From: Jennifer Hill
Sent: 17/03/2025 5:39:51 PM
To: Council Northernbeaches Mailbox
Subject: TRIMMED: Application Number: DA2025/0022 - 2230: 101 North Steyne, Manly.
Attachments: 2230.07.01.R1.Objection Letter to DA20250022_250317_SA.pdf;

101 NORTH STEYNE, MANLY – DA2025/0022 – OBJECTION TO A DEVELOPMENT APPLICATION

We have been engaged by the owners at 98-100 & 102-104 North Steyne Manly NSW 2095 to prepare this objection to the development application at 101 North Steyne, Manly (DA2025/0022). Architectural Projects has reviewed the submission and has provided a detailed list of issues. Architectural Projects has extensive Heritage, Urban Design and Planning expertise.

Neighbourhood Scale

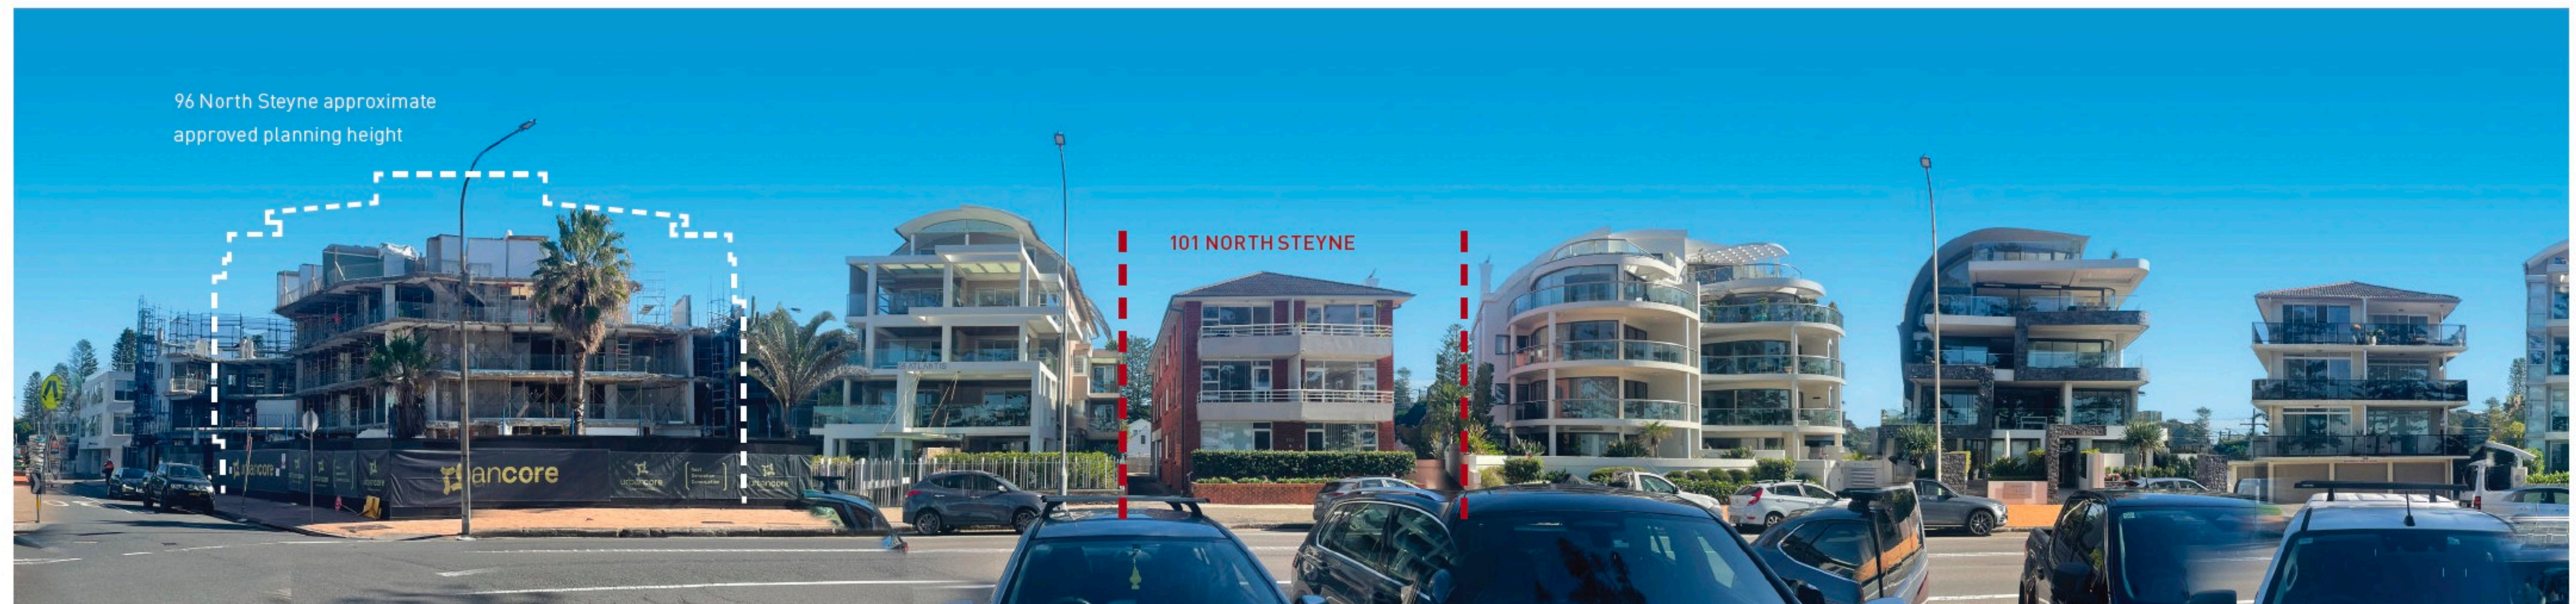
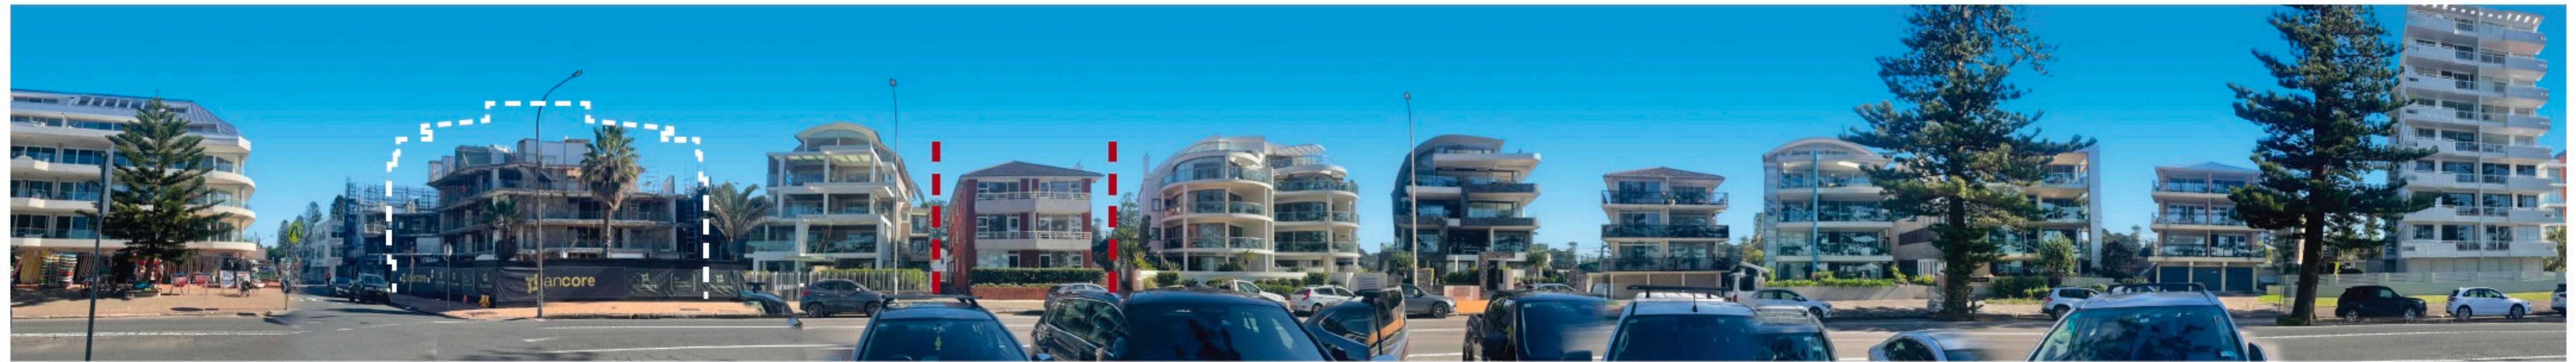
The proposal sits below the height of the recently approved additions to 96 North Steyne and as shown above is consistent with the height in storeys of other nearby buildings. The additional overall height in relation to the immediate neighbours is required to meet current minimum ceiling height and flood planning requirements that were not in place when these residences were constructed.

The height control of 13m has a minor breach at 96-98 North Steyne & 102-104 North Steyne, Manly.

The site faces North Steyne where the existing architectural expression is characterised by 5-storey apartment buildings with parking at ground or basement level. 96 North Steyne to the south is currently under development and will comprise 5 storeys of accommodation with additional height for plant (shown in white).

1 EAST ELEVATION

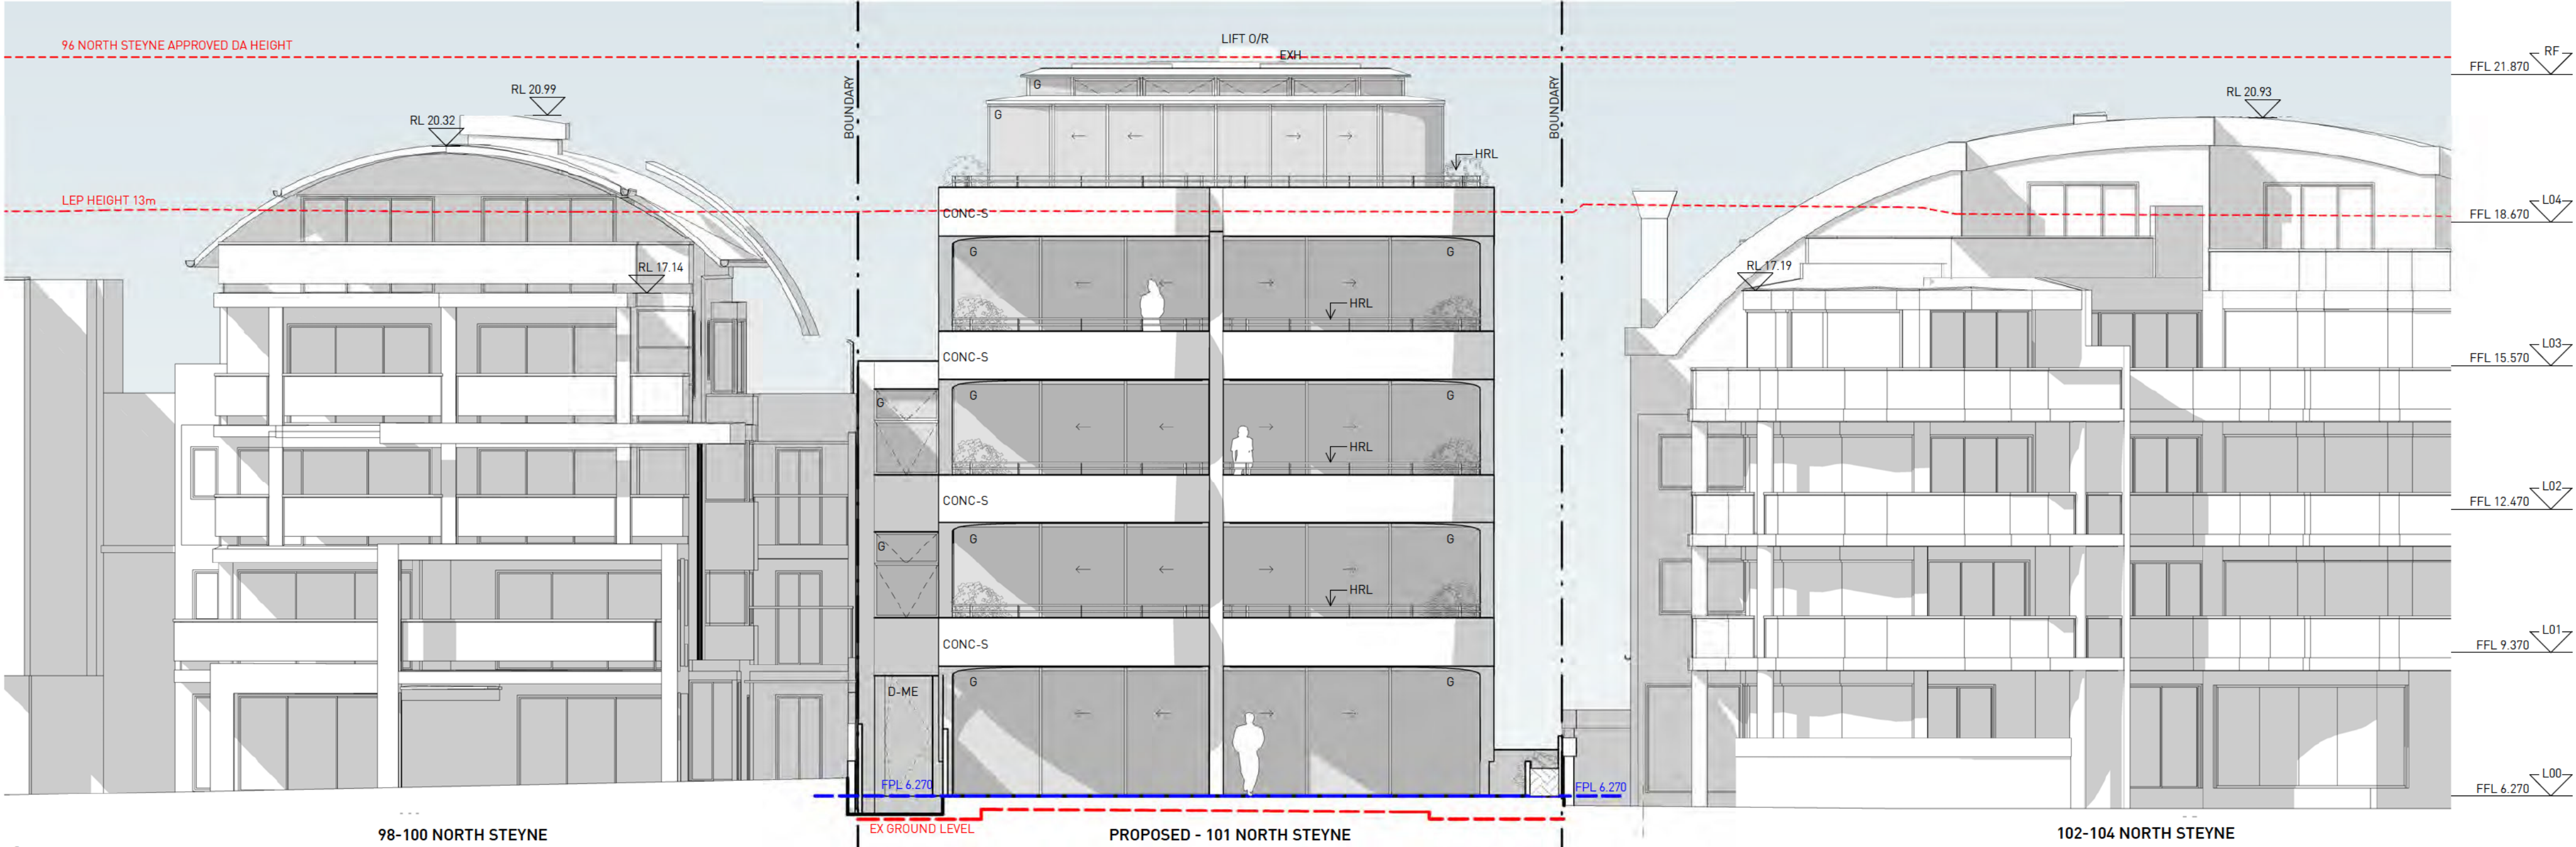
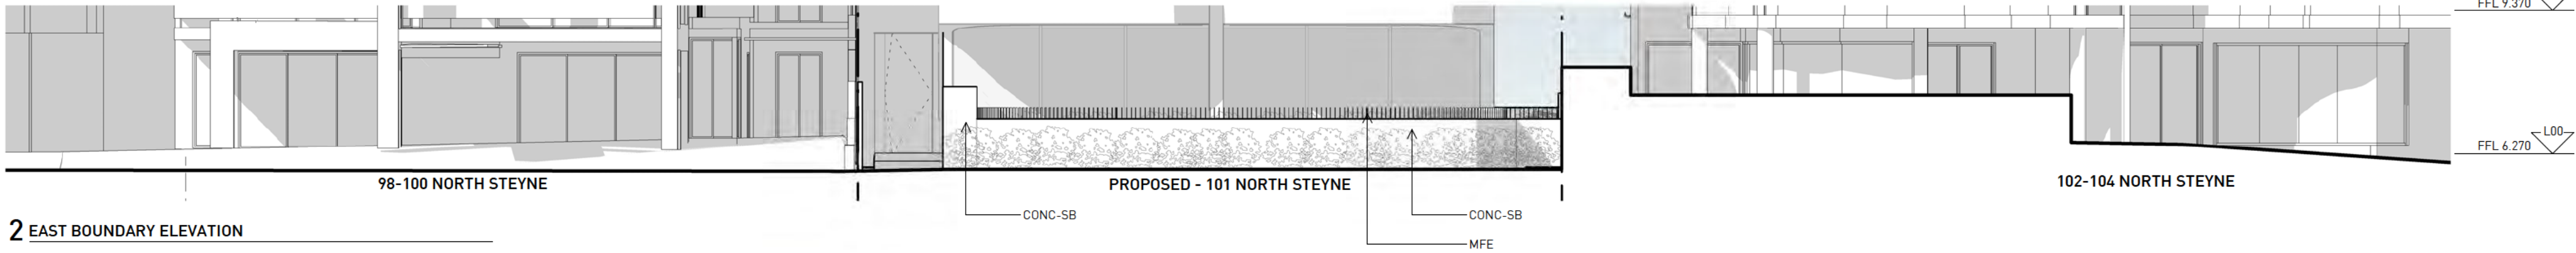
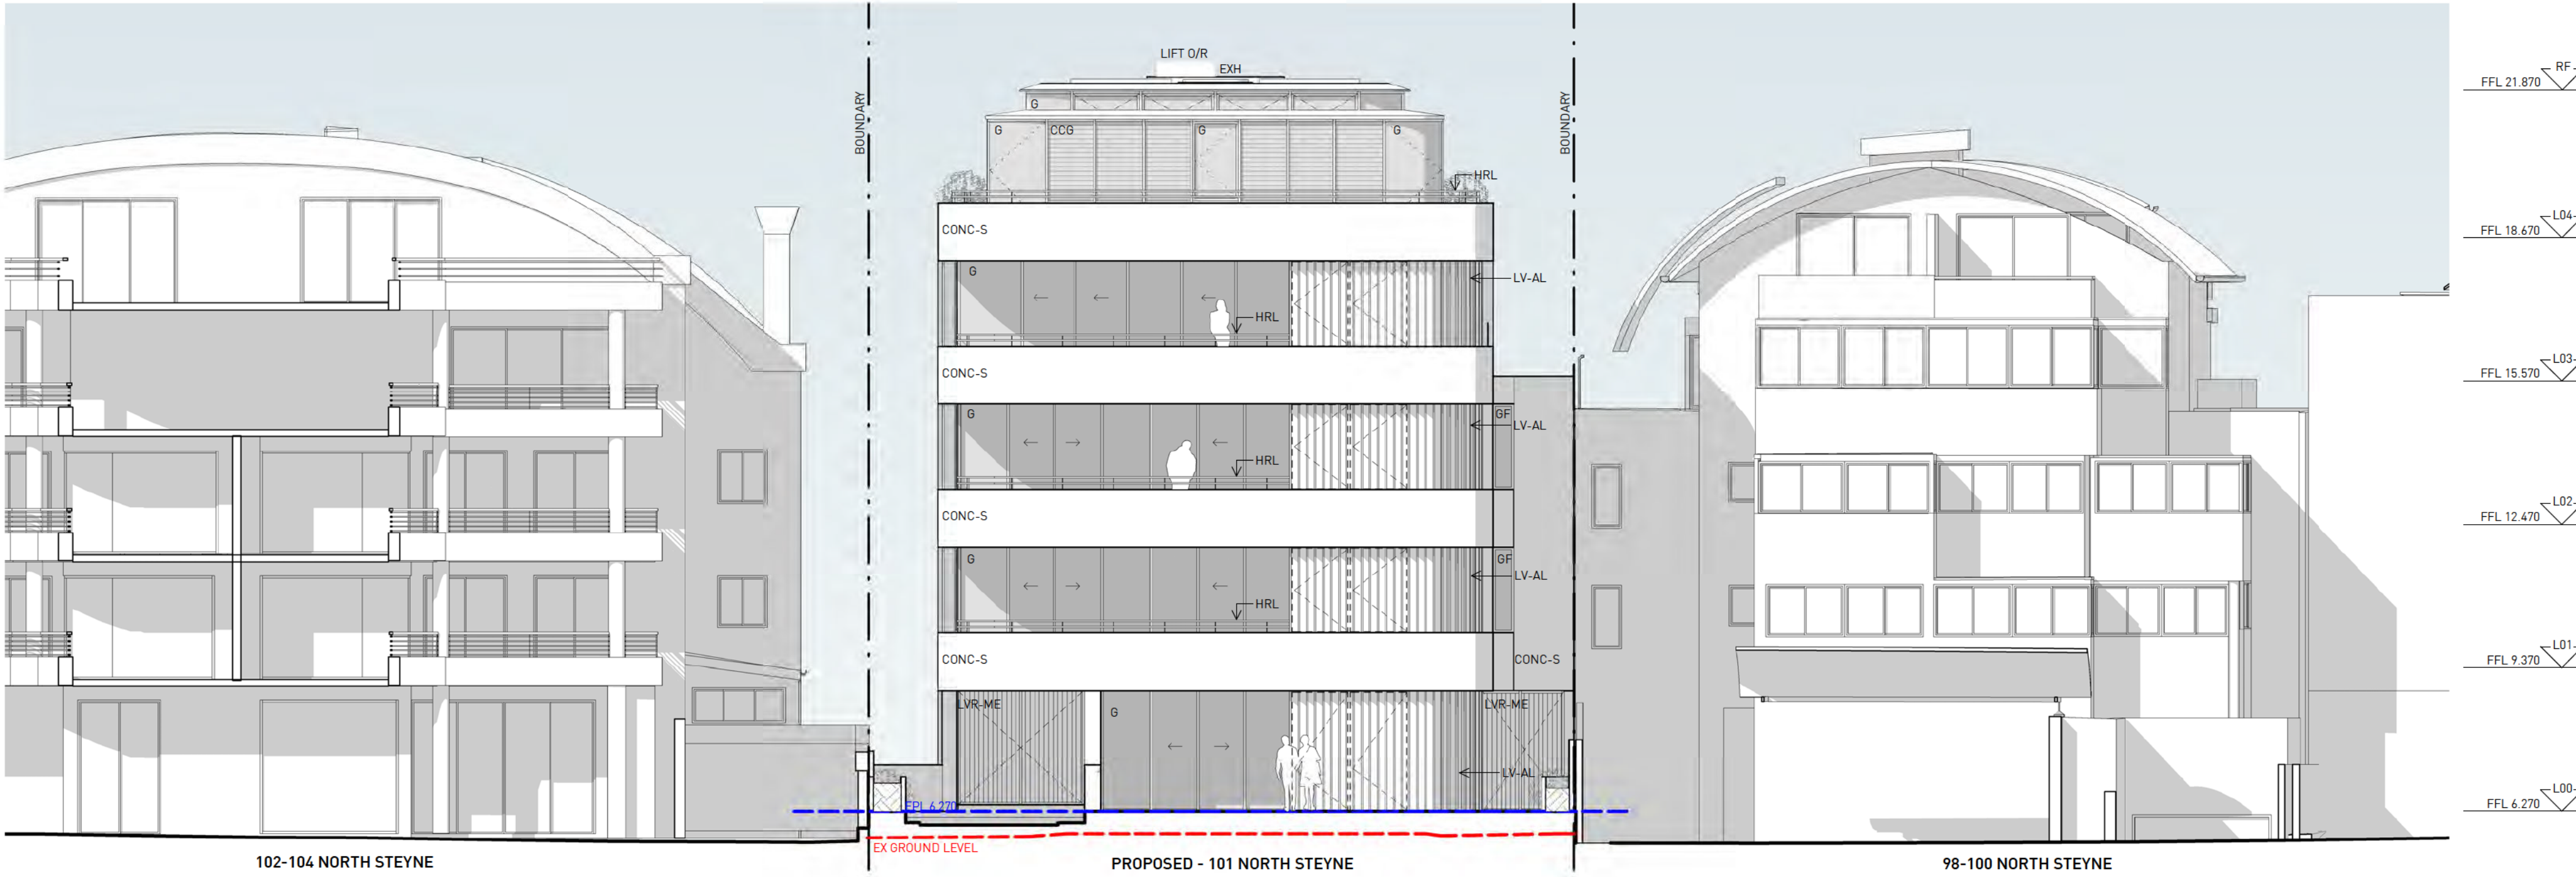
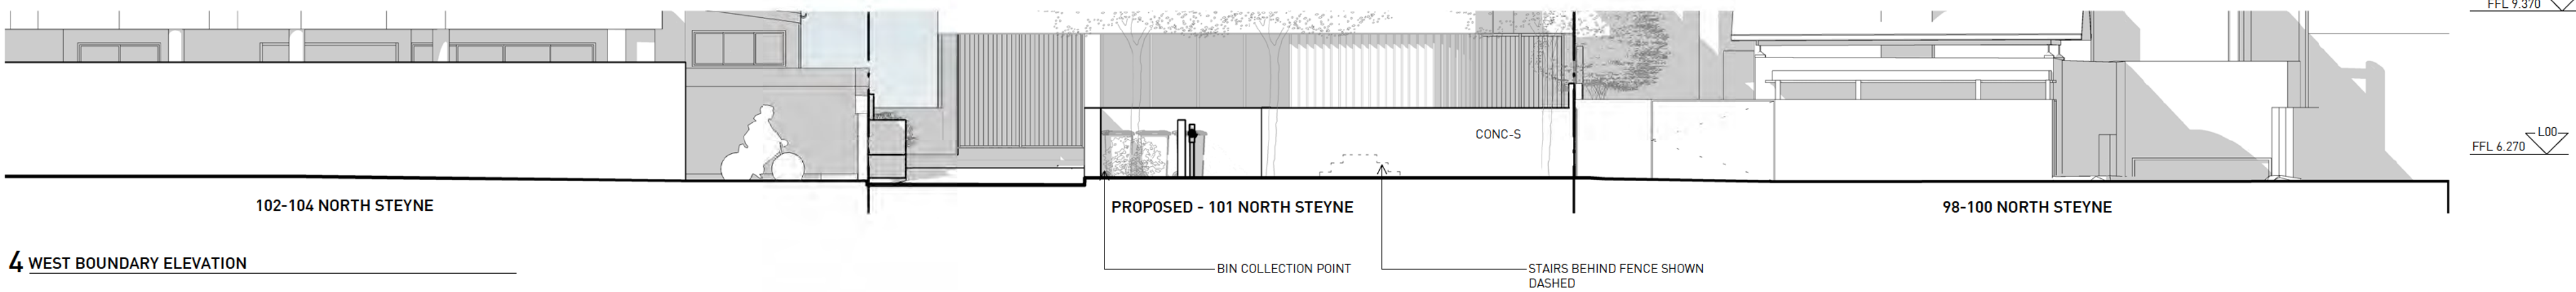
The wall height control is 12m. The proposed wall height of 13.5 or a 12.5% breach on the north elevation is a significant breach.

On page 17 of the Architectural Design Report and DA401A Elevations, indicates the balconies located substantially higher than the adjacent balconies.

The proposed **wall height** does not comply with the Manly DCP which contributes to the overall bulk and unsuitability within the streetscape. The maximum wall height permissible is 12m where the proposed development reaches a height of 13.15m. The site is not sloping which contributes to the overall bulk and unsuitability within the streetscape and there is no justifiable reason for the development to incorporate such non-compliance. A more articulated building that tapers towards the top of the development will relieve the large wall from having an overbearing impact upon adjacent buildings. The objectives of clause 4.1.2.1 of the Manly DCP are not satisfied.
